March 24, 2026

Re: Santa Maria Community Services
Project No. 25109
Addendum No. 5

## HANDICAP ACCESSIBLE PARKING SIGN

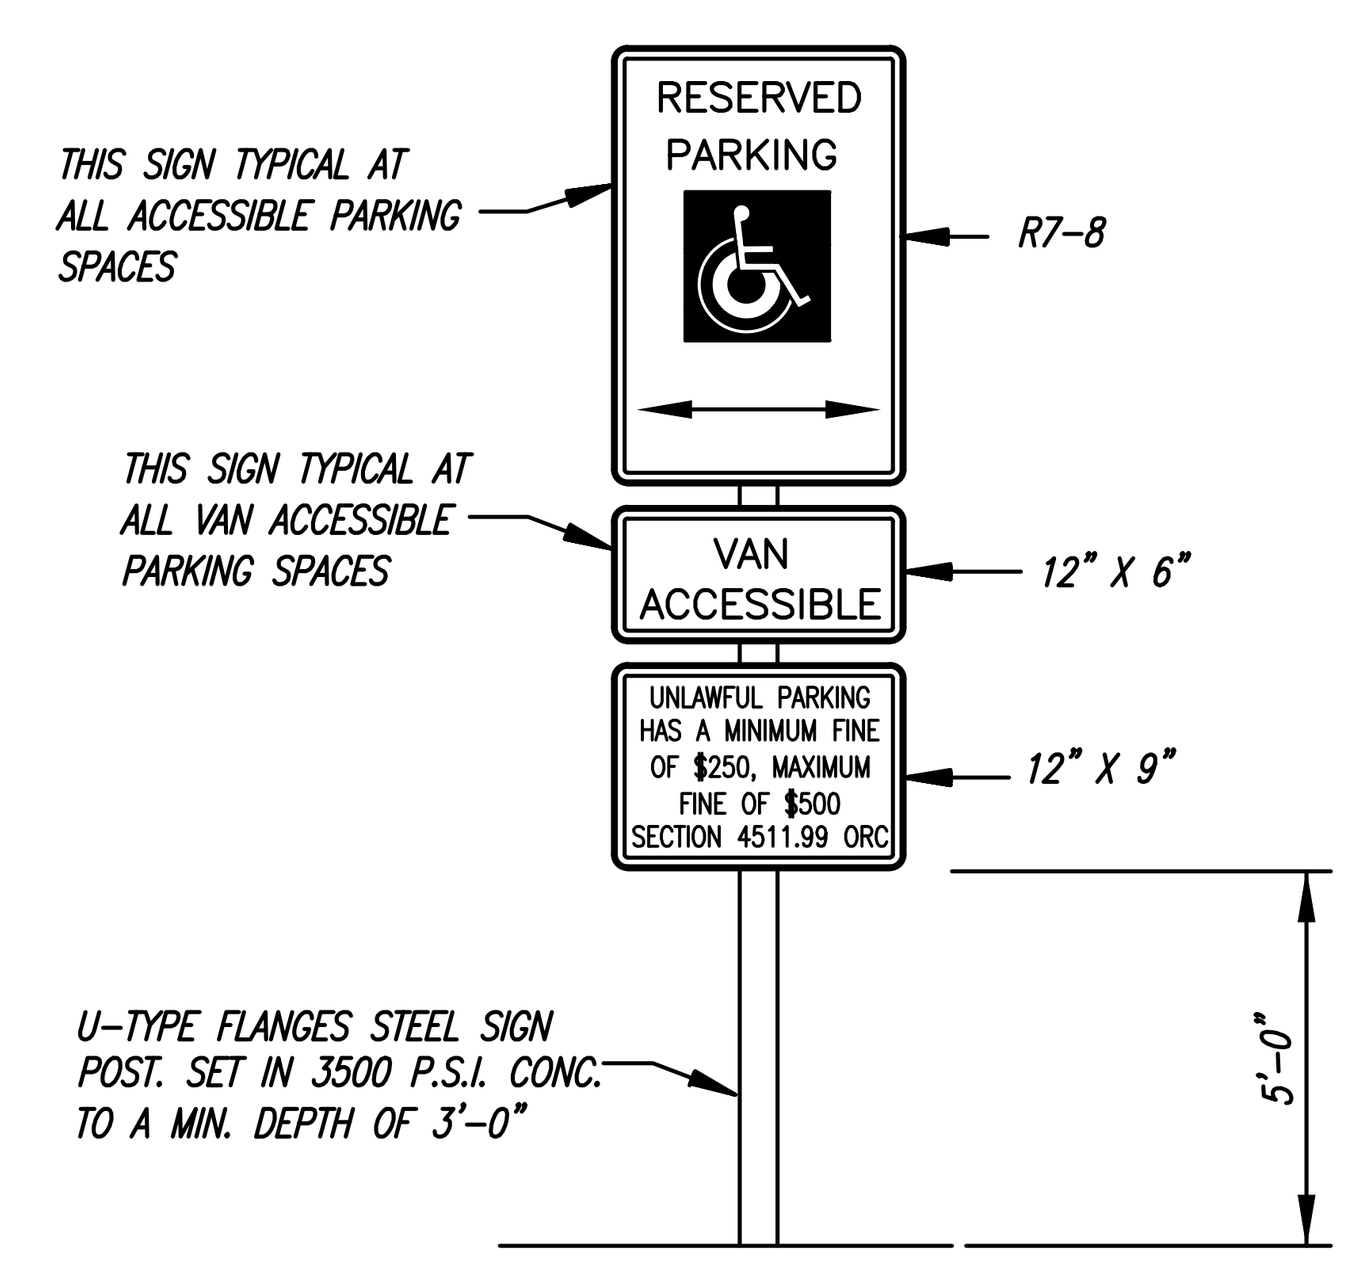
C101 Added Handicap Parking Sign Detail and Private Fire Hydrant detail.

| CITY OF CINCINNATI<br>DEPARTMENT OF TRANSPORTATION AND ENGINEERING | STANDARD COMMERCIAL DRIVEWAY CONSTRUCTION | APPROVED BY: CITY ENGINEER | DWG. NO. C116<br>DATE: 2024-08-23 |

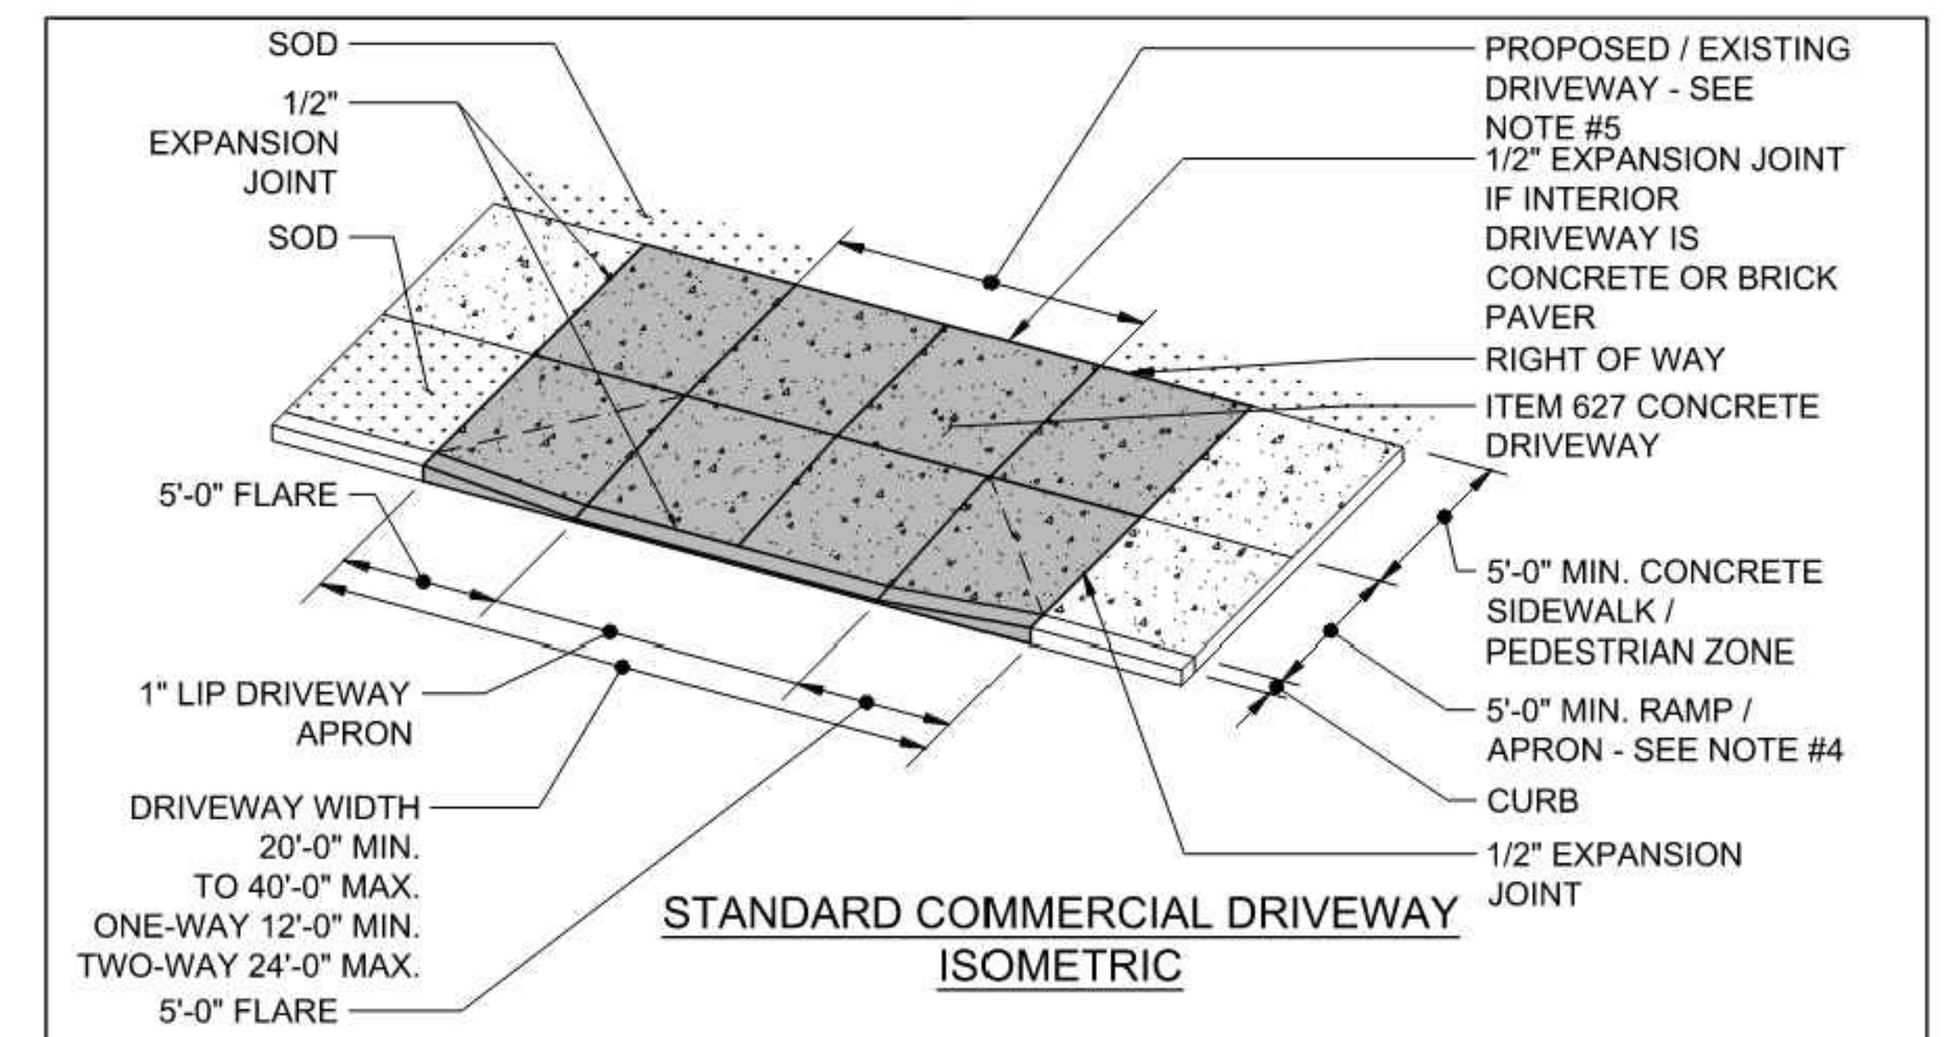
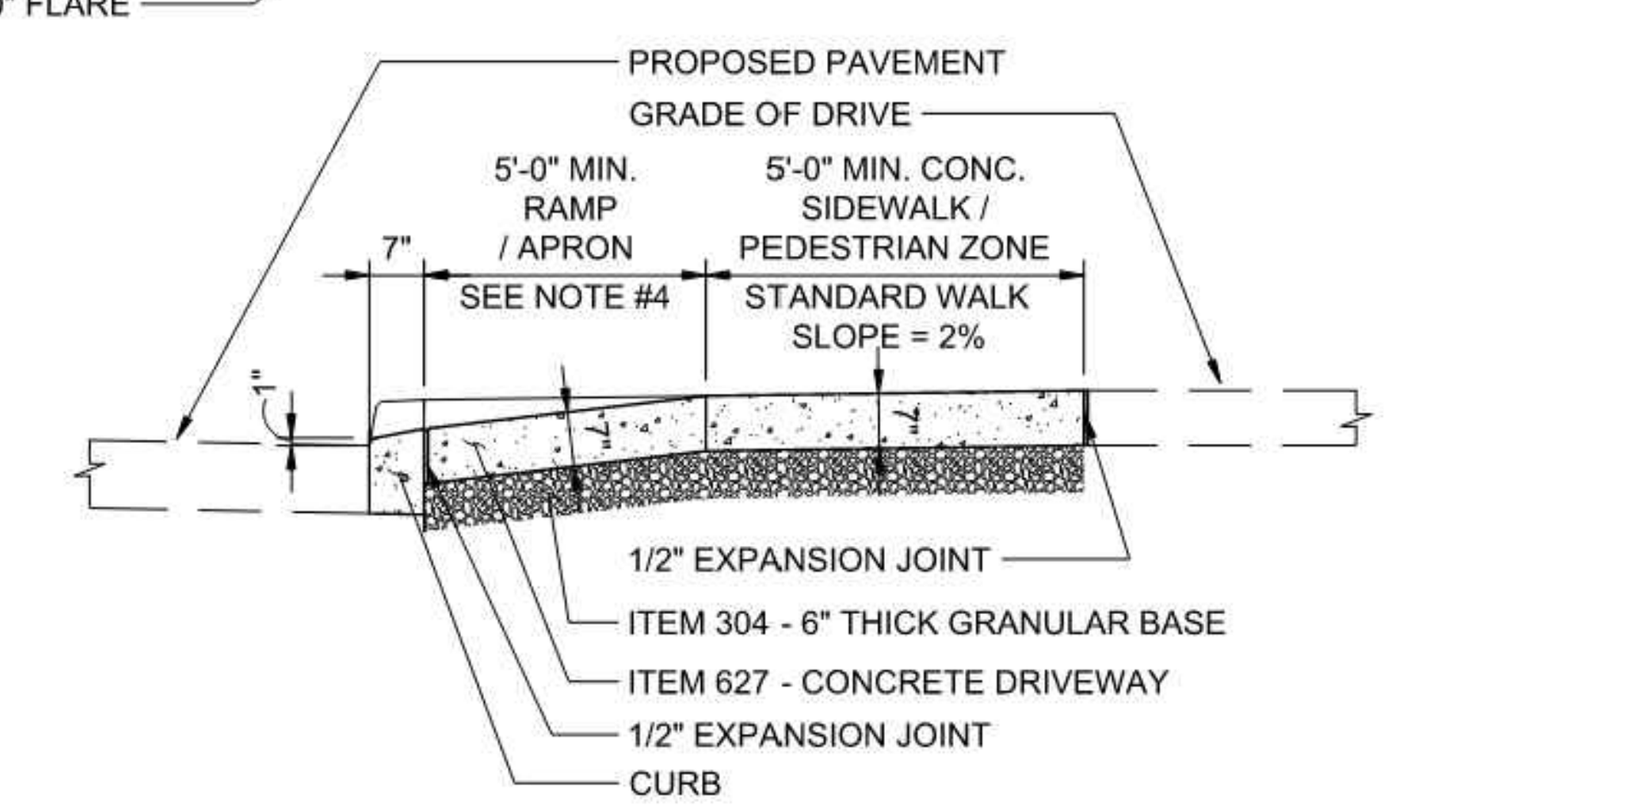
City of Cincinnati Dwg. #117, replaced with #116.

Sheet Title: UTILITY PLAN

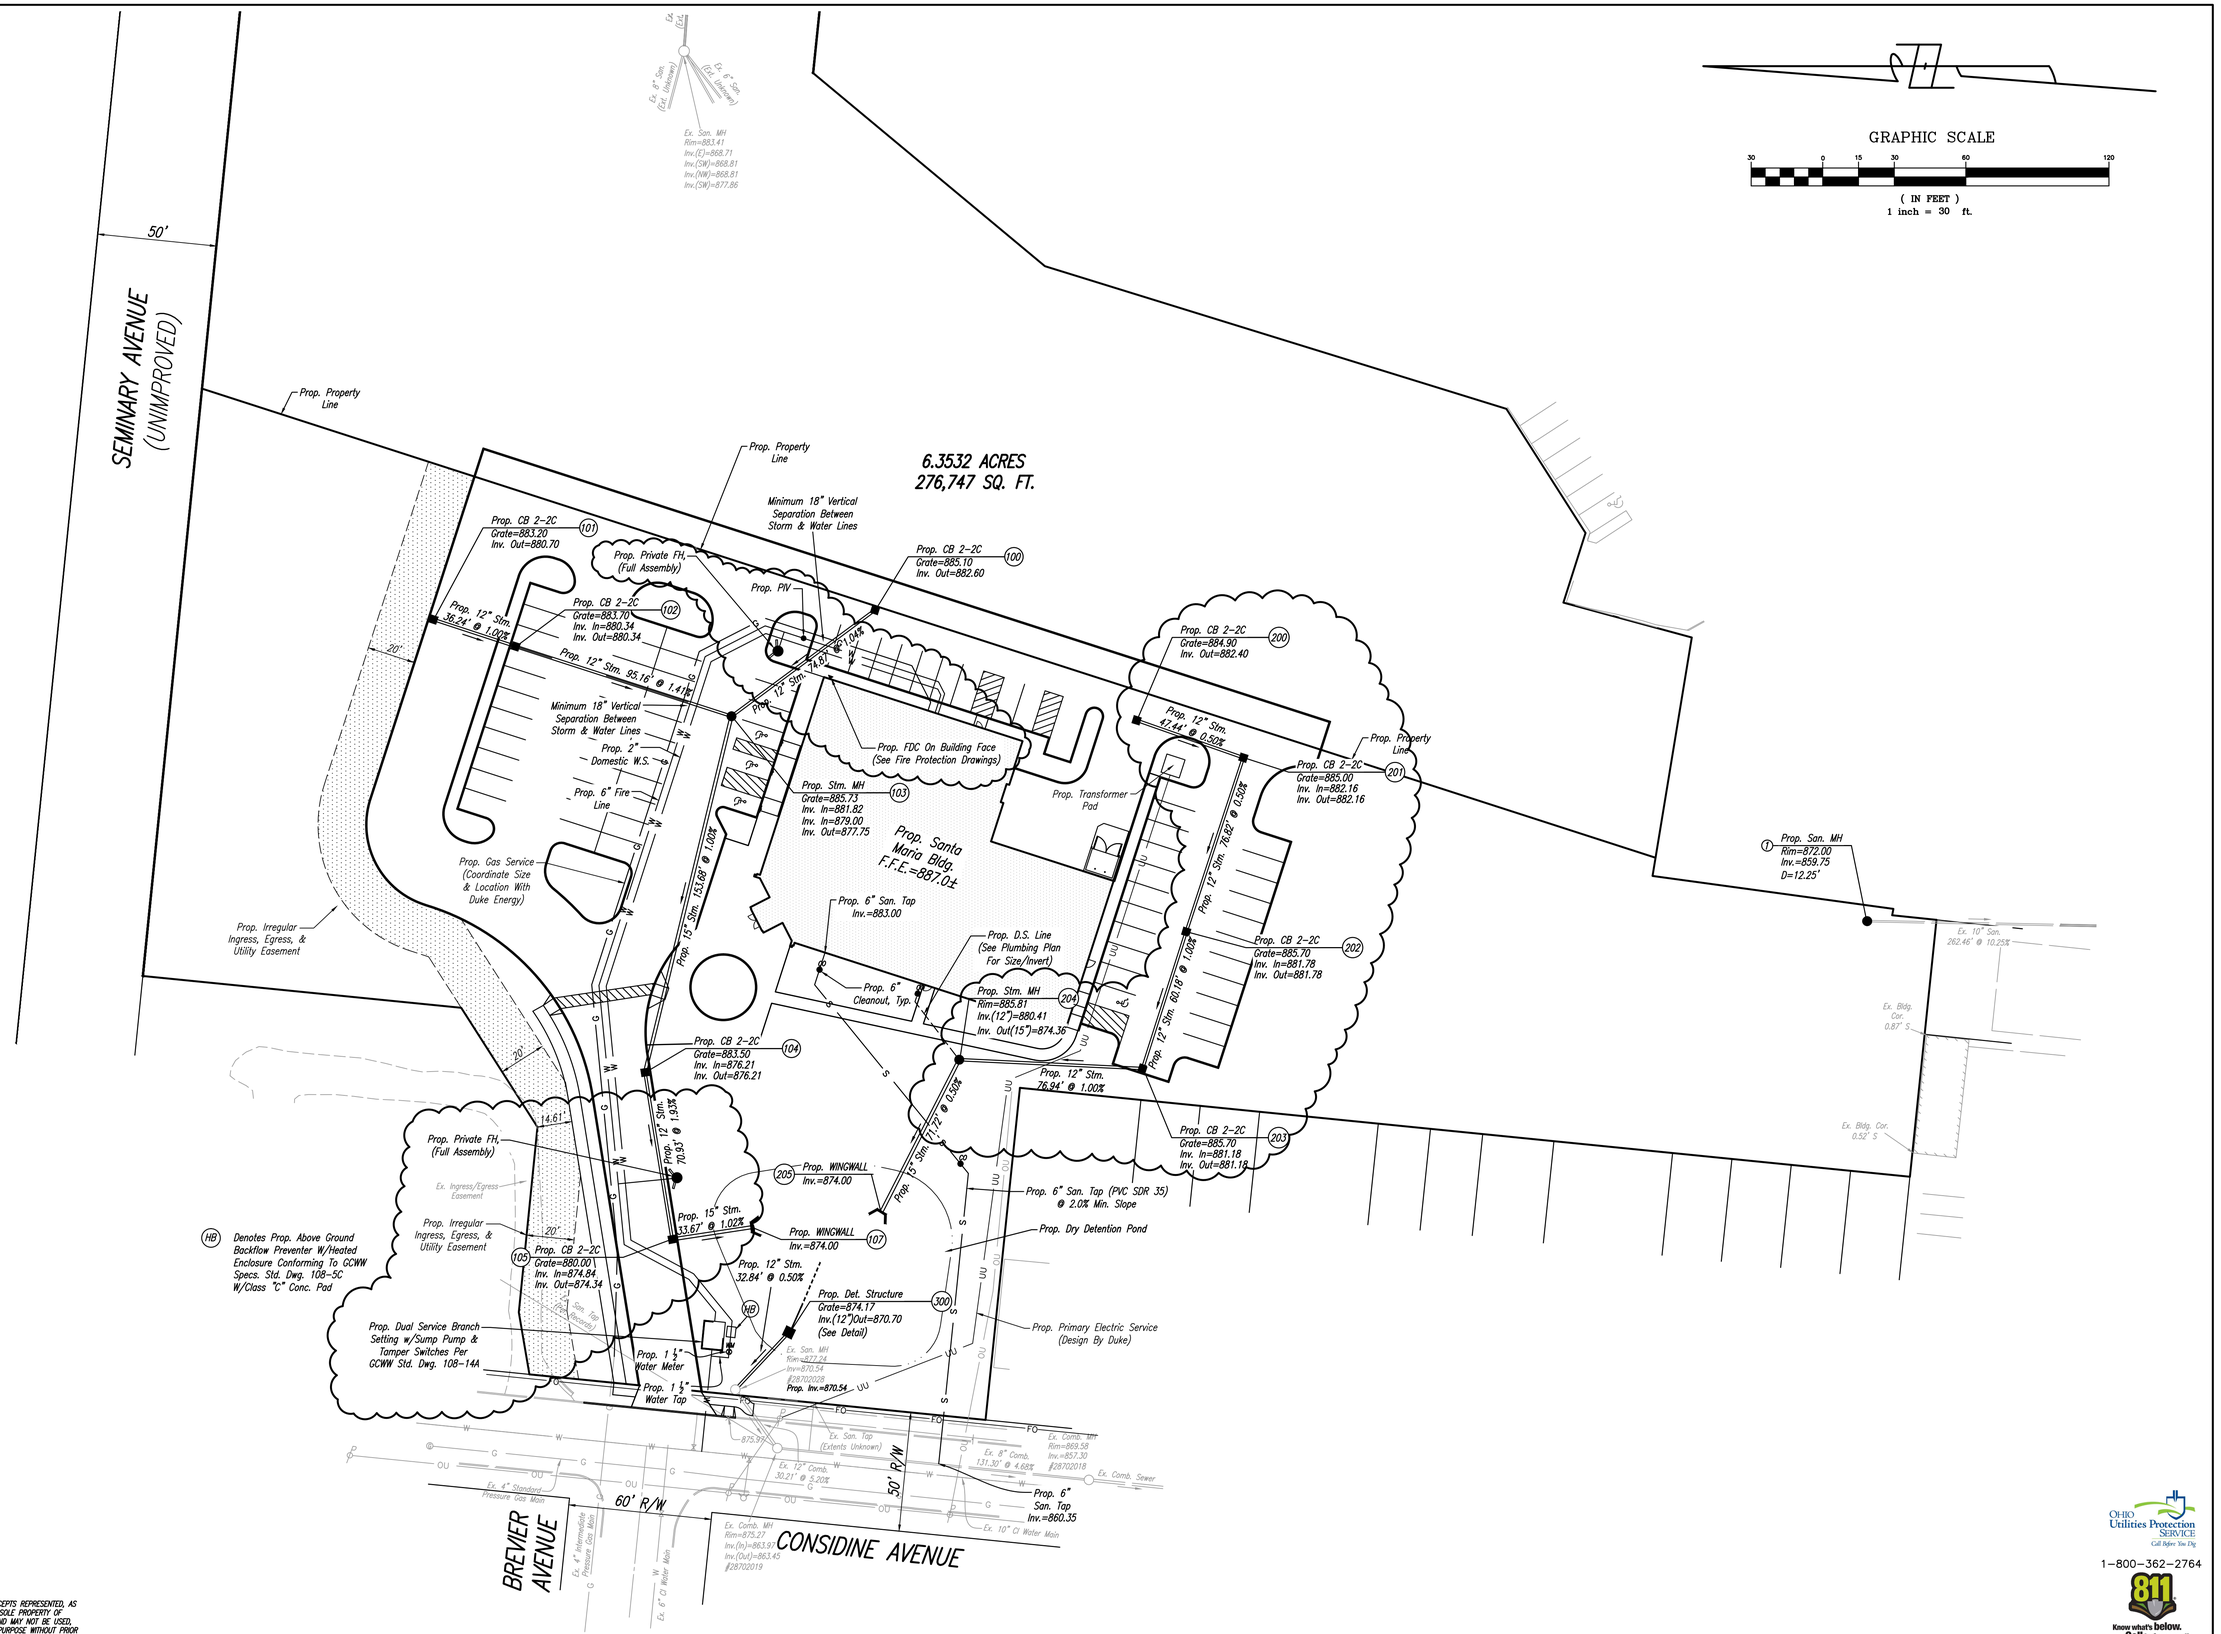
C400 Added (2) Private fire hydrants.

PIV and FDC moved from meter pit to northeast building corner.

Minor storm revisions to accommodate parking lot modifications.
